Spreeukloof Wind Energy Facility, Eastern Cape Province

Final Motivation for amendment of Environmental
Authorisation

DEA Ref.: 12/12/20/1778/5

October 2021

Figure 5.5: Comparative Viewshed Analysis for Spreeukloof Wind Farm

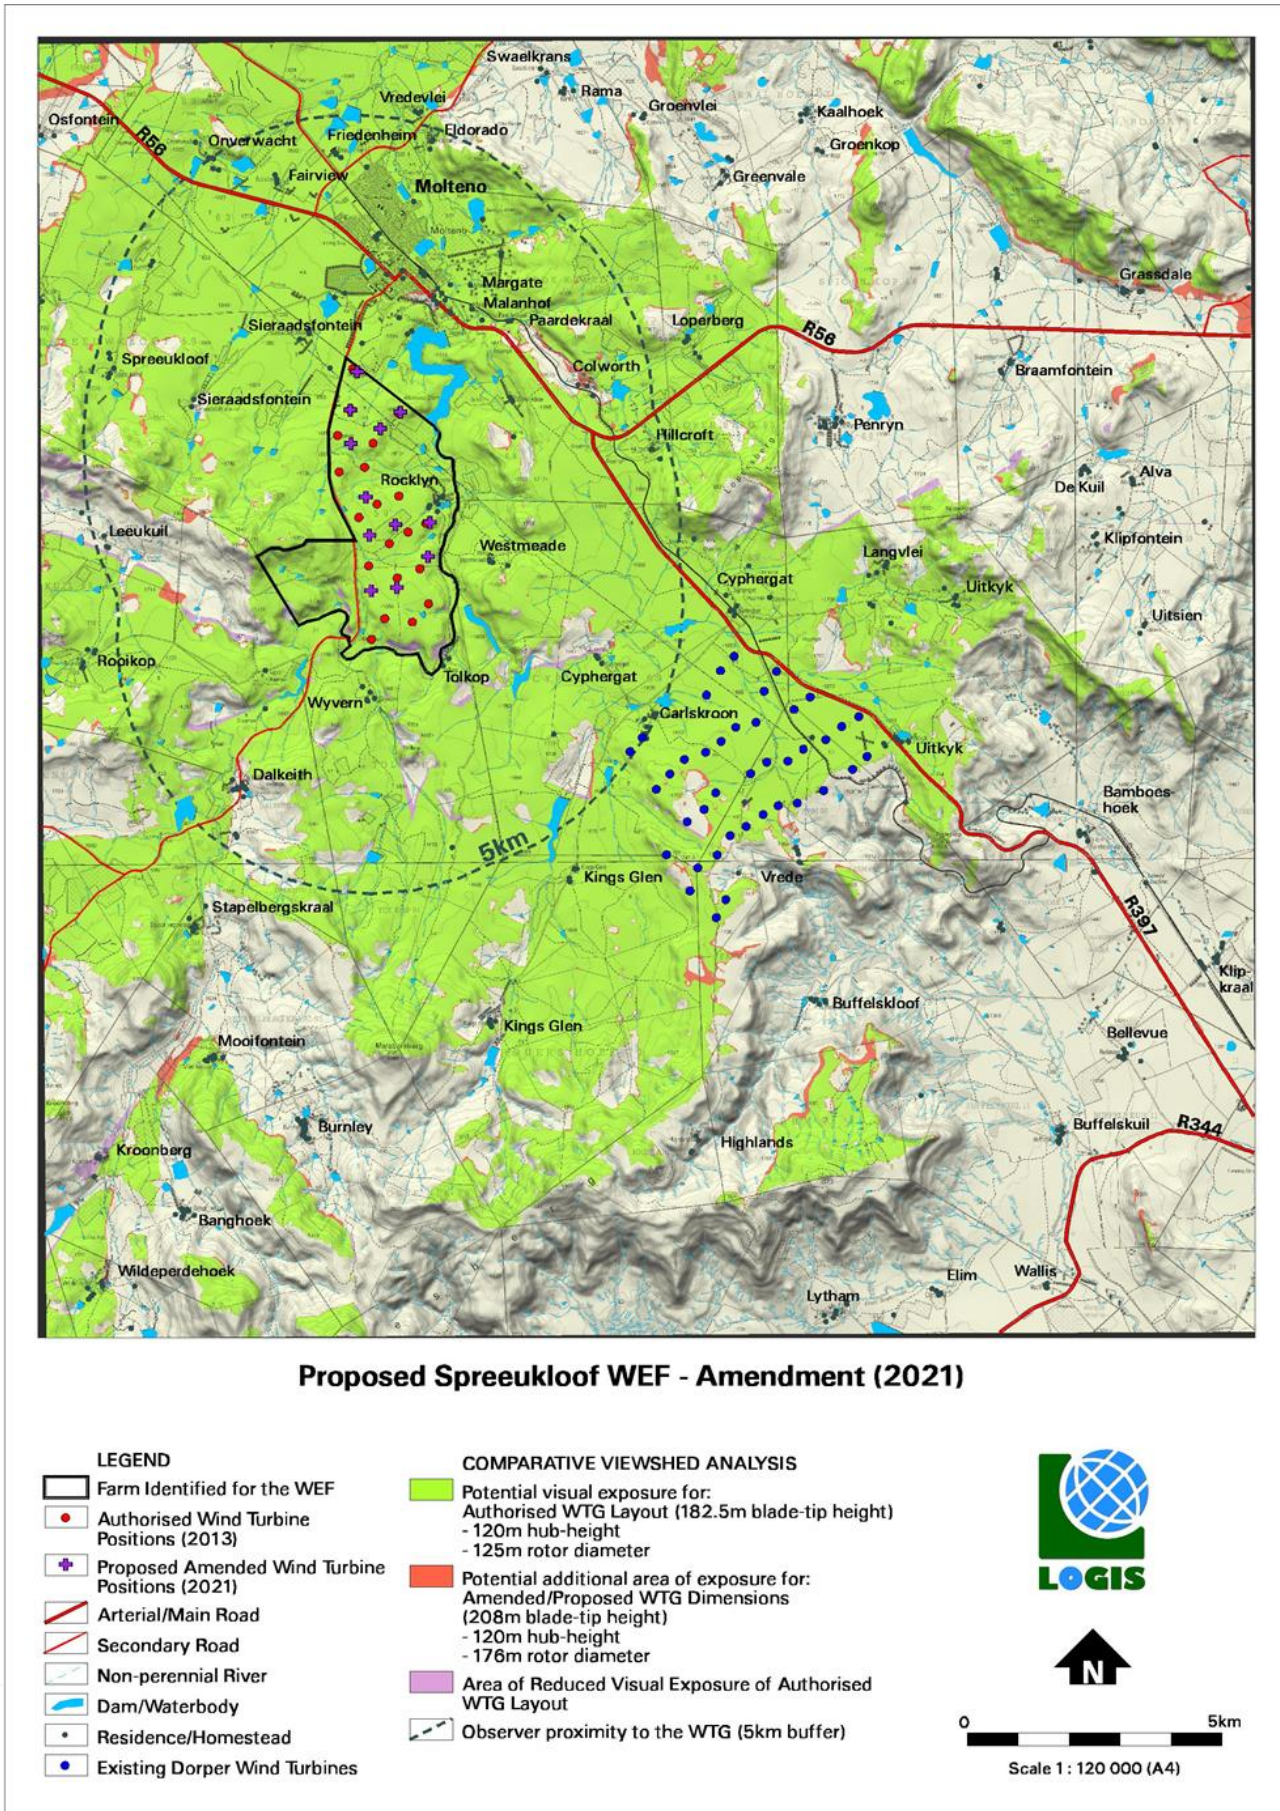
The analysis indicated that with the proposed amendments, approximately 12% increase in turbine dimensions, would have a relatively small influence on the overall visual exposure, due to the already tall turbine structures previously approved and the elevated positions of the turbines within the landscape. The surface area (within the study area) of the original turbine exposure is 274km², compared to the 277km² of the increased dimensions of the wind turbine exposure. This is an increase of 3km², or alternatively, an increase of less than 1% in potential visual exposure. It should be noted that the above calculation includes an area of 4km² that represents the surface area that won't be visually exposed after the reduction in the number of wind turbines.
